ADDENDUM 4

Date Issued January 30, 2026

Project Name | Job # White Earth Withdrawal Management Facility 20237410

THIS ADDENDUM AMENDS AND BECOMES PART OF THE CONTRACT DOCUMENTS FOR EAPC PROJECT 20245580 DATED 12/5/2025, RESPECTIVELY. EACH BIDDER SHALL ACKNOWLEDGE RECEIPT OF THIS ADDENDUM BY MARKING THE ADDENDUM NUMBER AND DATE ON THE BID FORM.

DRAWING TITLE
GAS PIPING PLAN

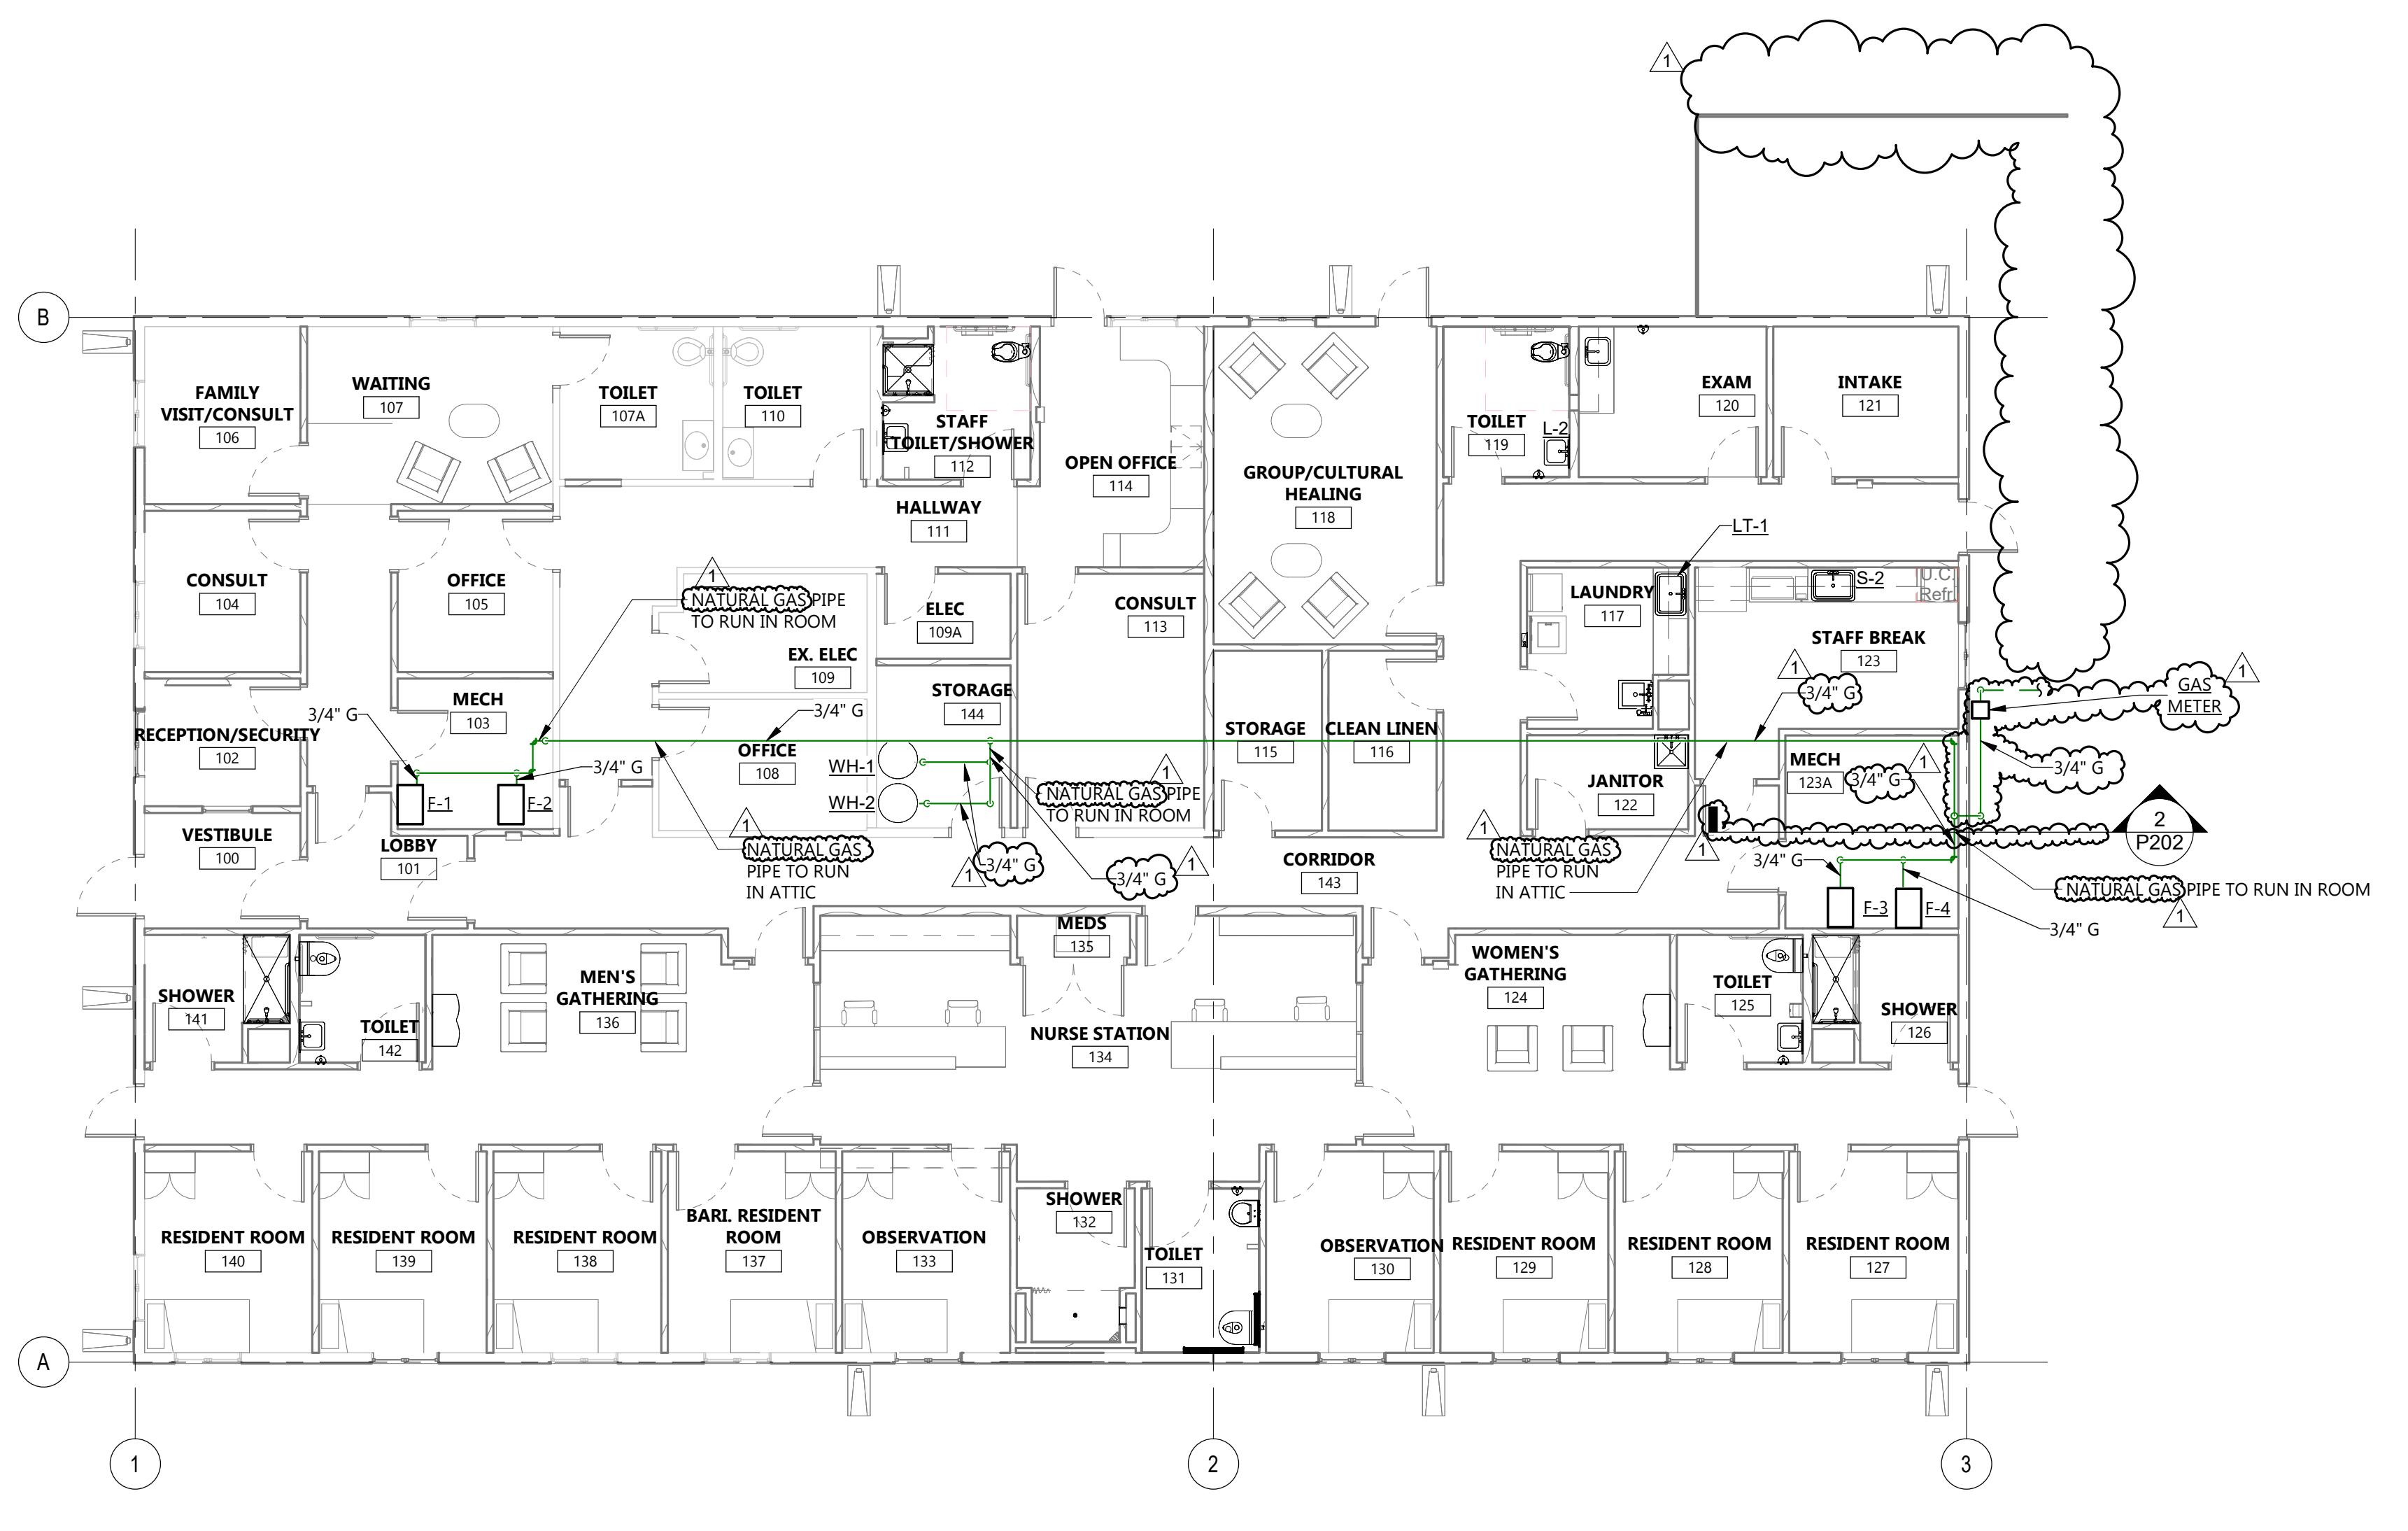
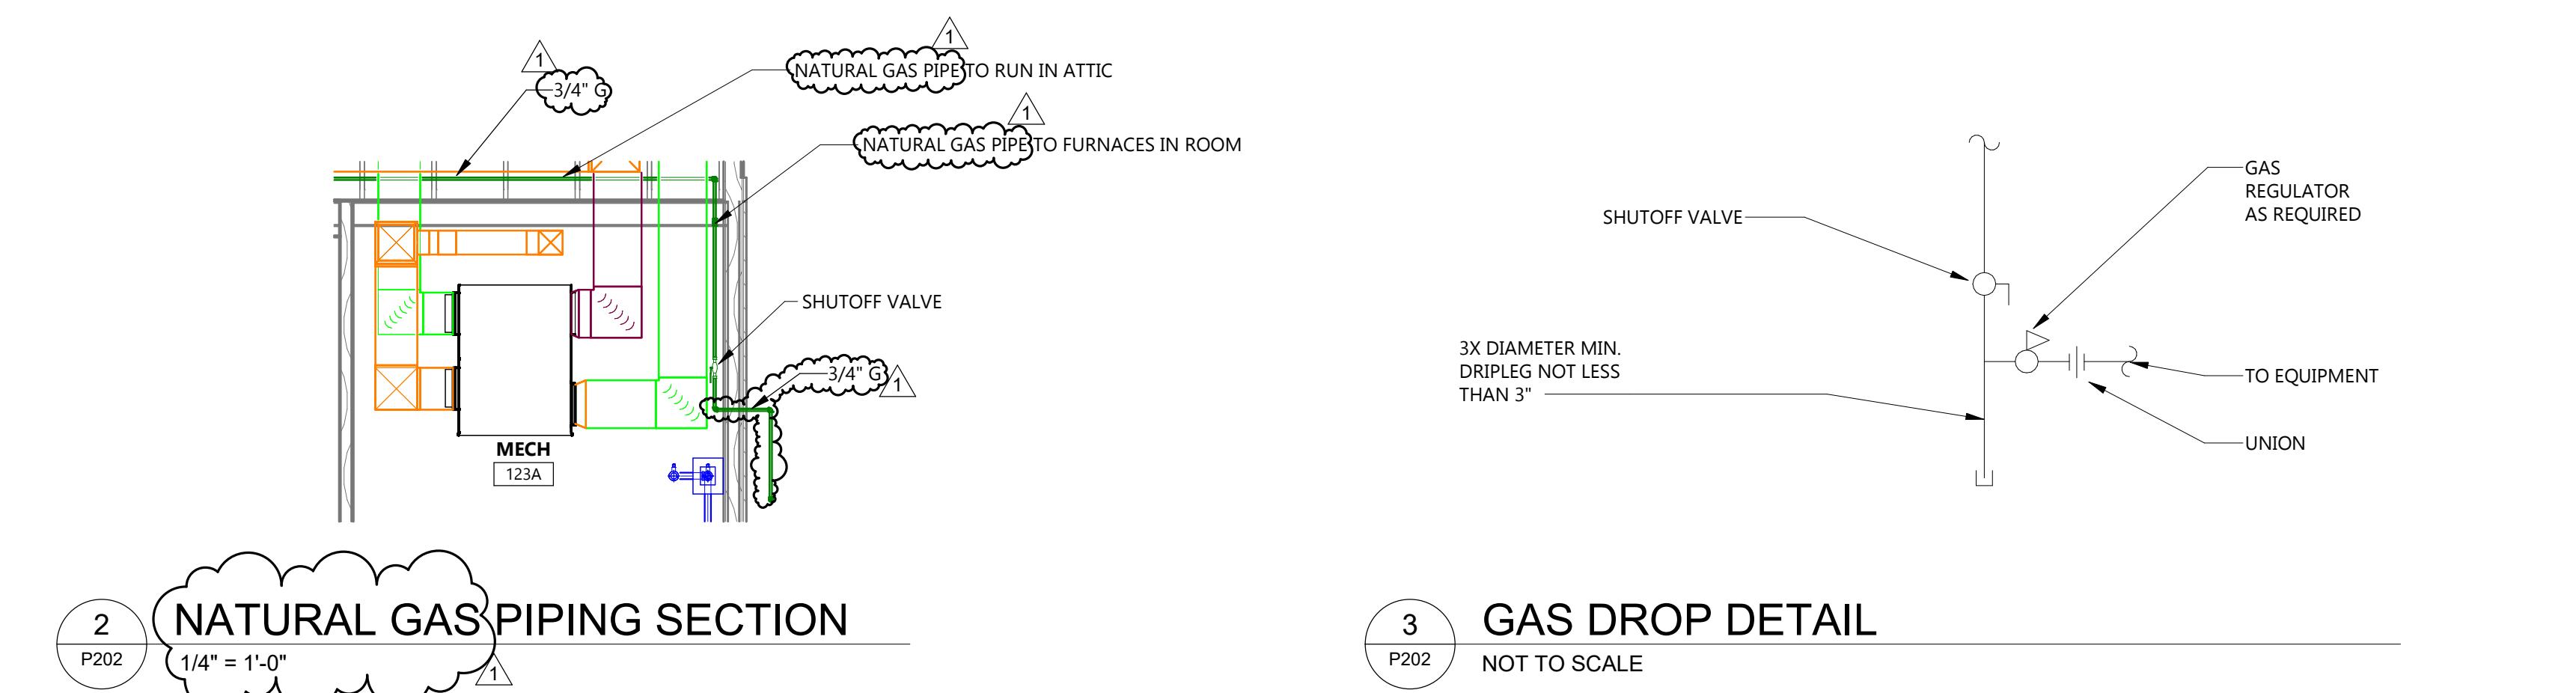
A101	Modify demo note AD08 to read AD09.
A301	Add ceiling access panel to room 117. See attached A301.
A801	Modify doors 116, 117, 118 .1, 119, 120, 121, 122, 123, 123A, 133, 130, 134.1, 134.3 to be 20 min fire rated. See attached A801.
P101	Change demo items to include all propane equipment
P202	Changed propane piping and related equipment to natural gas piping and equipment
P801	Changed water heater fuel from propane to natural gas
M801	Changed furnace fuel from propane to natural gas
